Oyster Creek Generating Station  
Facility Operating License No. DPR-16  
NRC Docket No. 50219

**Subject:** Clarifications to Responses to NRC Request for Additional Information related to Severe Accident Management Alternatives (SAMA) for Oyster Creek Generating Station (TAC No. MC7625)

**Clarifications Associated with SAMA RAI Responses**

Figure 1c-1 Review Process for Oyster Creek PRA Model

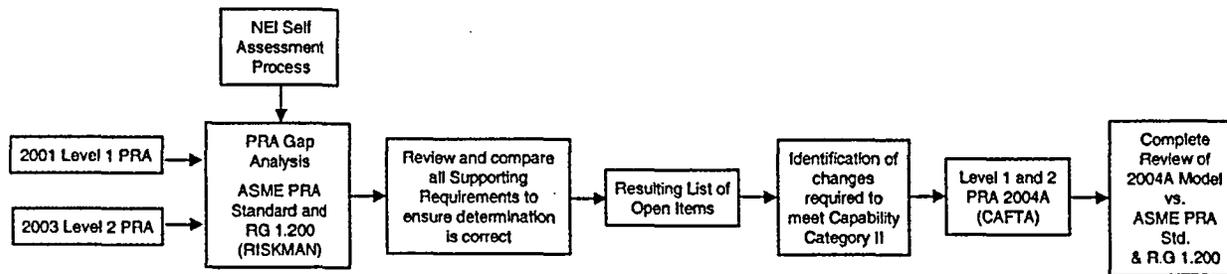
*Was the 2004A analysis subjected to a complete self assessment or was the focus of the re-review limited to those gaps found in the 2001 PRA? Of concern is the completeness/applicability self-assessment of the 2001 PRA relative to the 2004A model considering the extensive changes from the 2001 model to the 2004 model not the least of which is the change from support state (RISKMAN) modeling to linked fault tree (CAFTA) modeling.*

The Oyster Creek 2004A model, documentation, and results were subjected to a complete self assessment to ensure that they reflected the insights from the RISKMAN model and the model changes made during the 2004A model preparation.

Following development of the 2004A model, it was then completely re-assessed using the Ref. [1] and [2].

Figure 1c-1 summarizes this process.
